Submissions and Amendment Report

SSD-70283710

*Crescent Parklands
1 Crescent Street, Holroyd*

Figure 4 Proposed Amendments to Built Form, Height and Massing (North Elevation)

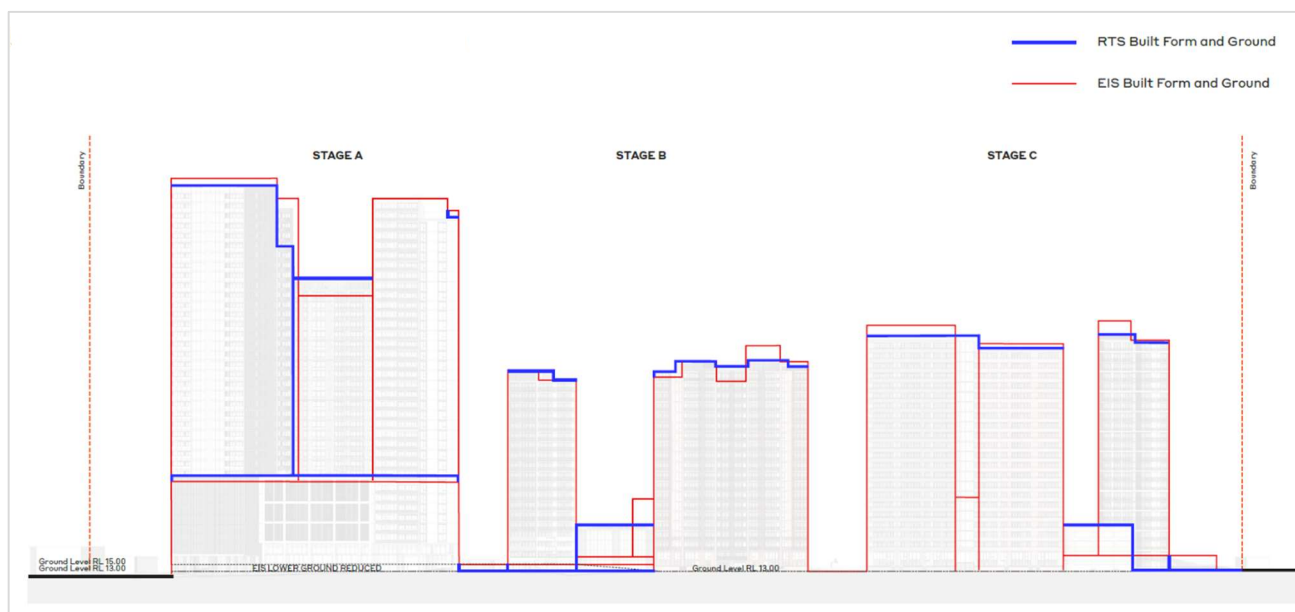
As a result of the reduced podium heights, the layout of the car parking areas within the podiums have been rationalised to improve efficiency. The revised car parking layouts create additional space for communal open space on the rooftop of Stages B and C while reducing the perceived bulk and scale of the podiums. The amended car park layouts also improve vehicular circulation and wayfinding and provide a clearer separation between residential, retail, and commercial parking areas.

The proposed amendments to built form, height and massing are shown in the following figure.

Figure 5 Original SSD Site Layout

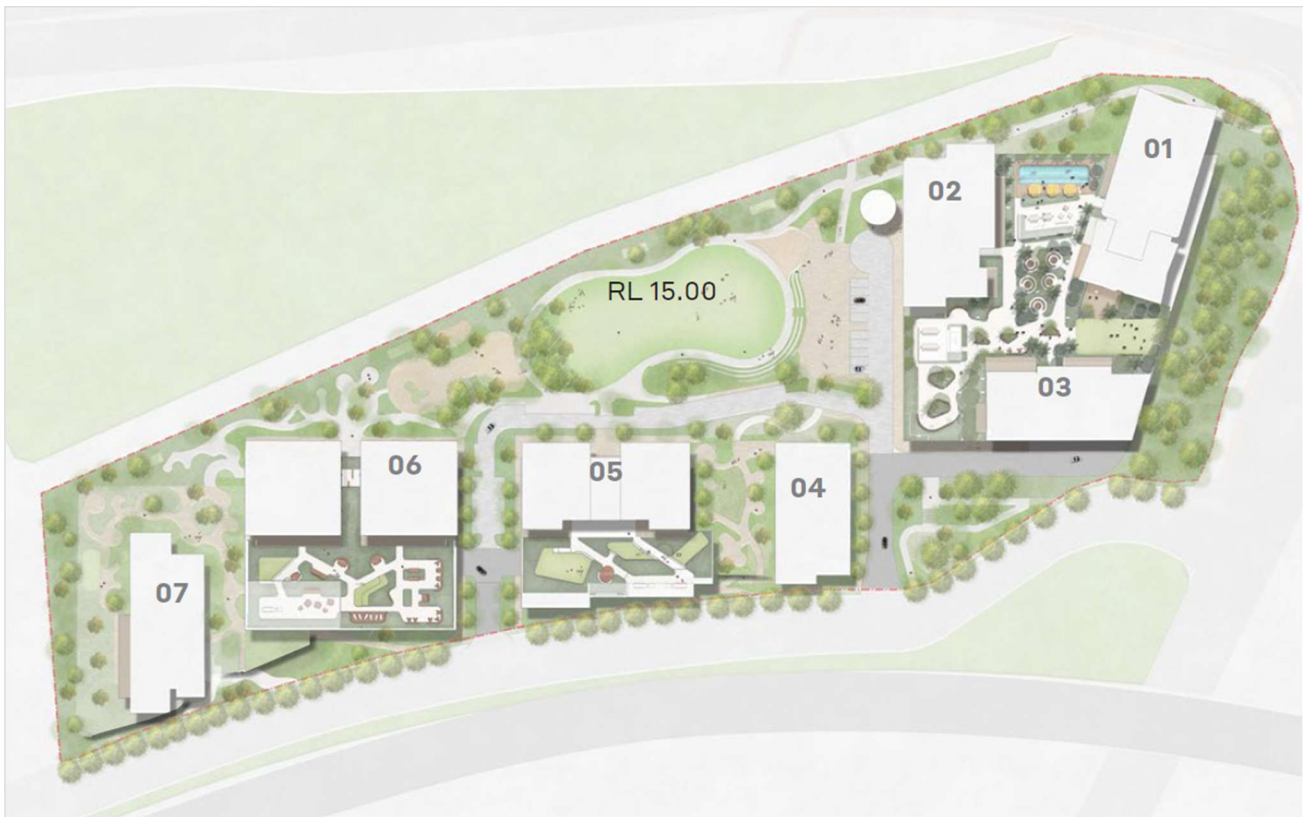
A comparison of the original SSD site layout and the proposed site layout (as amended) is shown in the following figures. Indicative photomontages of the amended proposal are also shown below.

Figure 13 Site-Wide Comparison of Podium Footprints (Original SSD and Amended Proposal)

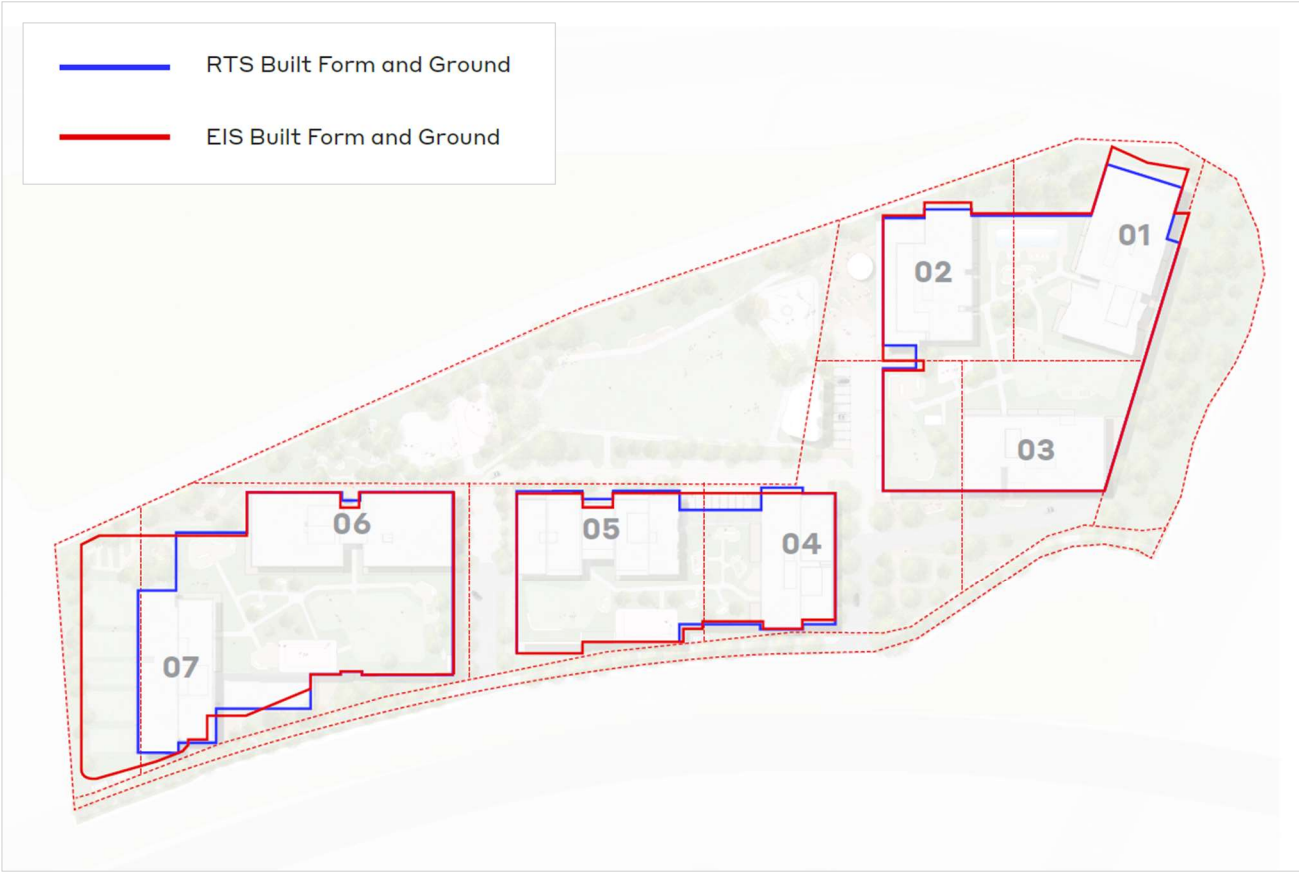
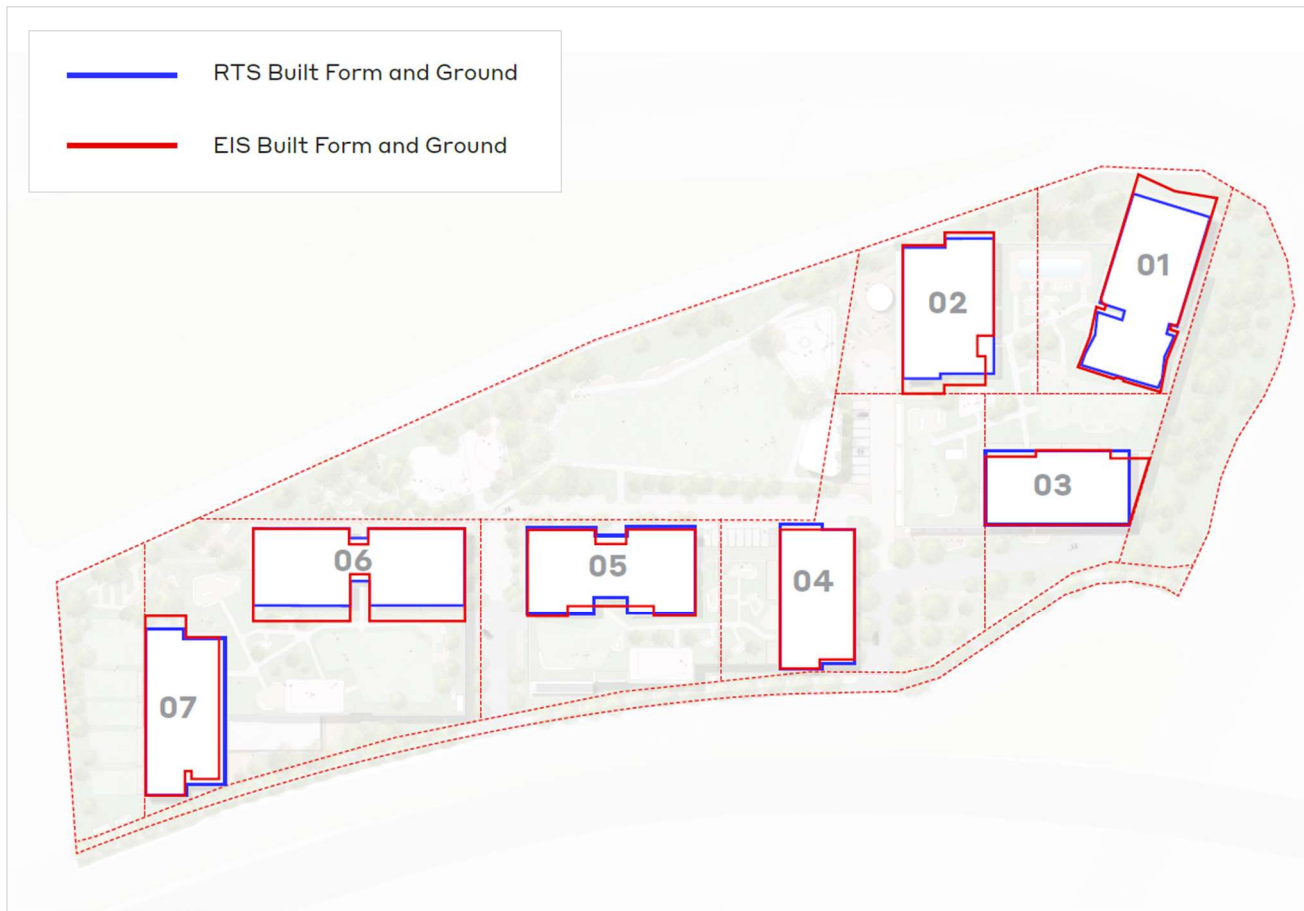
The podium massing has been generally maintained (in plan) within the amended proposal. However, the ground floor RLs have been lowered internally within the podiums to improve the ground level pedestrian experience and enhance connectivity with the adjacent commercial / retail uses fronting the park.

The reduction in building footprints within the amended proposal is shown in the following figures.

Figure 15 Original SSD Building Footprints (Southern Elevation)

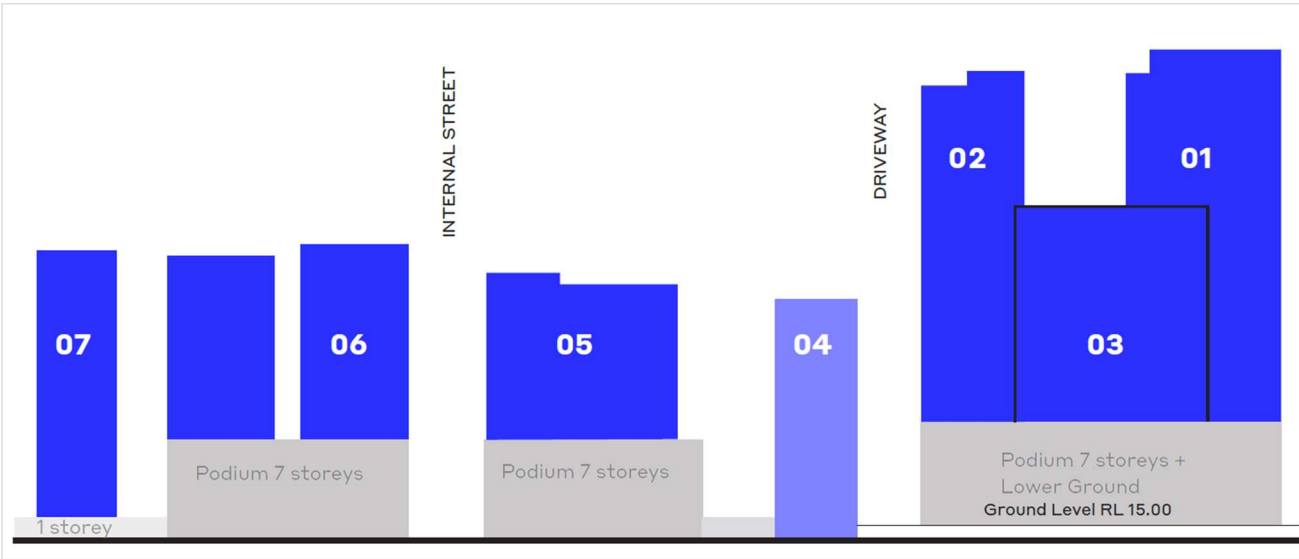
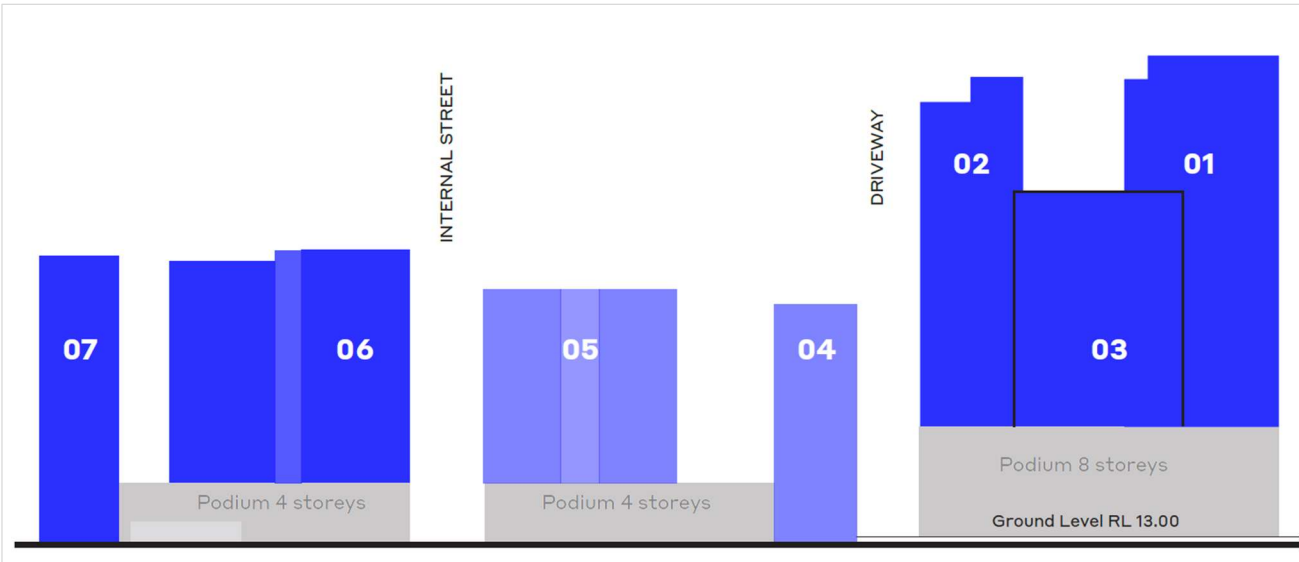
This increases sunlight penetration through the site, establishes a more human-scaled relationship with adjoining streets and open spaces, and improves the perceived visual impact of the podiums from the ground level. The redesigned podiums also enable more generous rooftop amenity spaces within Stages B and C which are easily accessed by residents of Buildings 4-5 within Stage B, and Buildings 6-7 within Stage C. The spacious rooftop amenity within Stage A has also been retained within the amended proposal.

The proposed reduction in podium heights between the original SSD and the amended proposal is shown in the following figures.

Figure 17 Proposed Amendments to Built Form, Height and Massing (North Elevation)

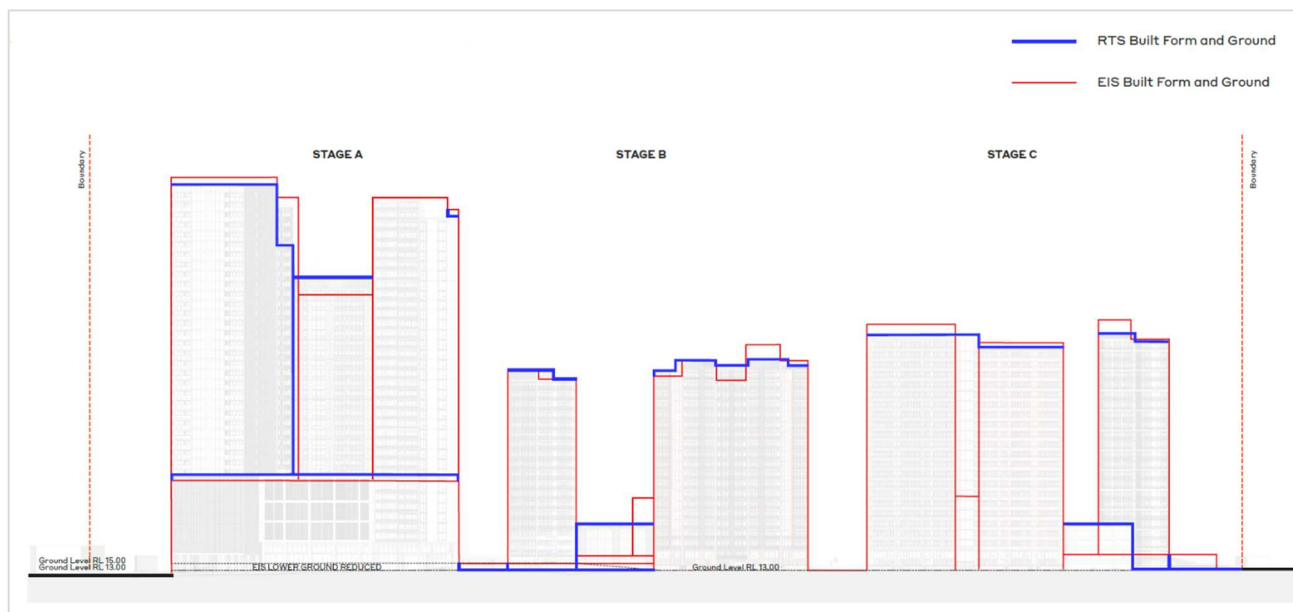
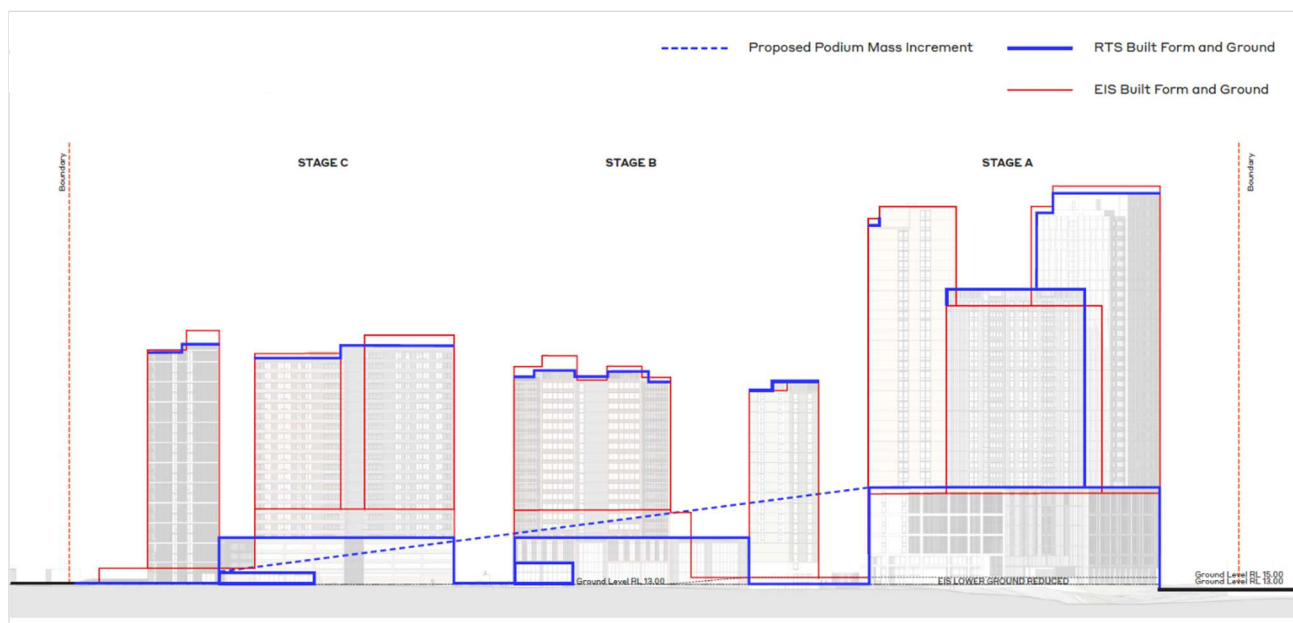
Overall, the amended proposal achieves a more balanced distribution of height across the precinct. Despite Building 3 increasing in height, this complies with the maximum permissible building height. The increase in height to Building 3 is also offset by the reduction in height to other buildings. This ensures that the proposed built form across the precinct remains consistent with the original design intent while also improving the relationship to the ground plane and surrounding context.

The proposed change in building heights between the original SSD and the amended proposal is shown in the following figures.

Figure 25 Mitigation Measures – Dense Landscaping (Red), Extended Awnings (Blue) & Porous Screening / Raised Planters (Green)

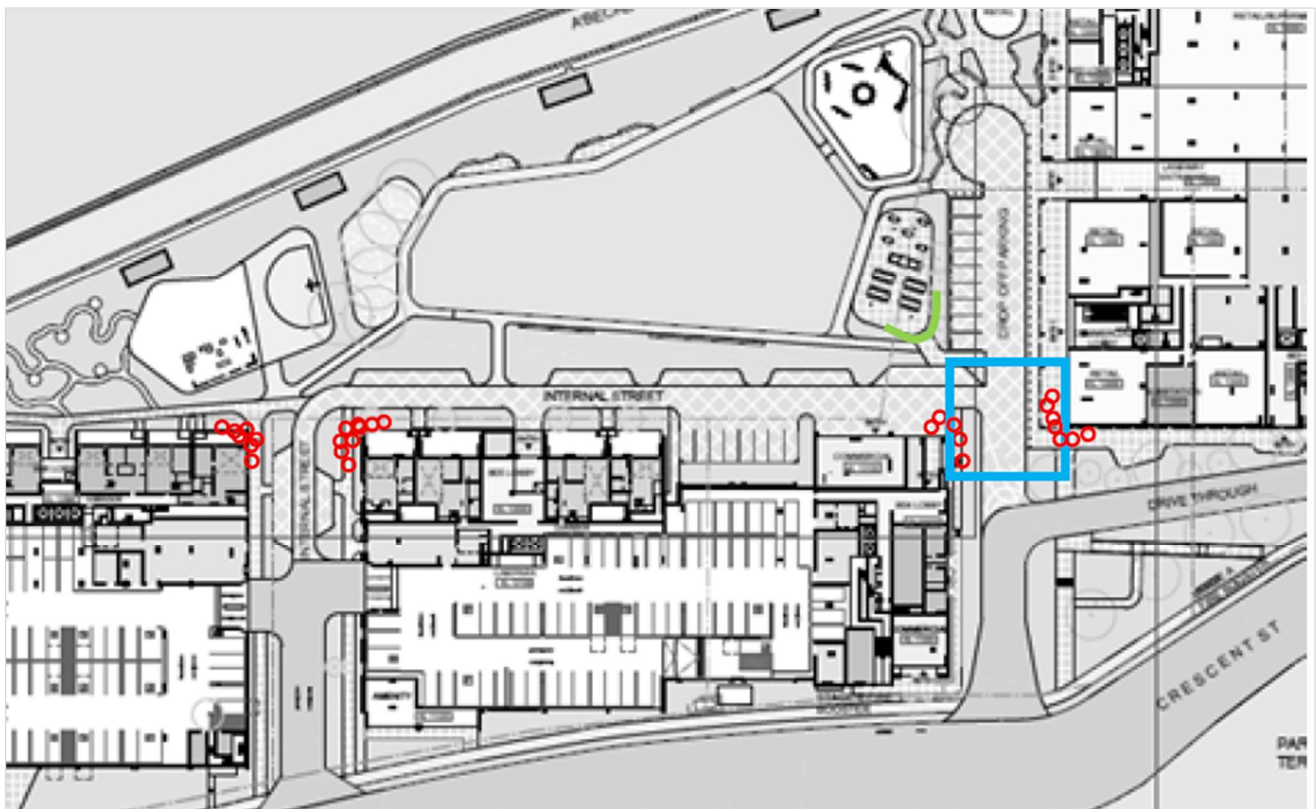
- Increased the balustrade heights to approximately 1.8 metres in identified locations.

The location of these recommended mitigation measures are shown in **Figure 25** below. Refer to the revised Wind Impact Assessment included at **Appendix O** for further details.

Figure 29 Amended Ground Floor Public Open Space and Private Open Space

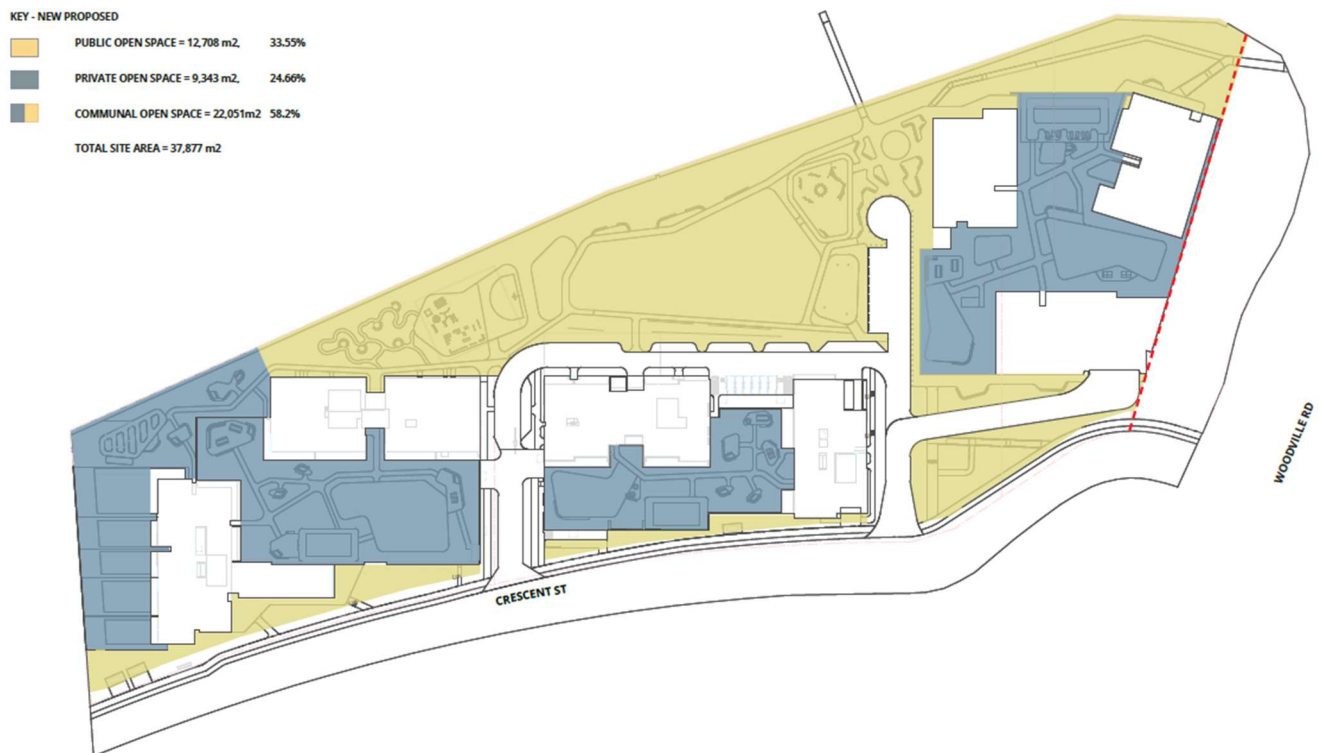
The reconfiguration of the public domain strengthens activation and usability by grouping key program elements such as the communal lawn, all-ages play space, adult and senior fitness zones, shaded seating, and central shareway. These spaces are now more legible and accessible, encouraging all-day use and enhancing passive surveillance across the precinct.

These improvements create a more vibrant, functional, and secure environment for all users. The revised design of ground floor public open space and private open space within the amended proposal is shown in the following figure. Refer to the revised Landscape Plans at **Appendix J** for further details.
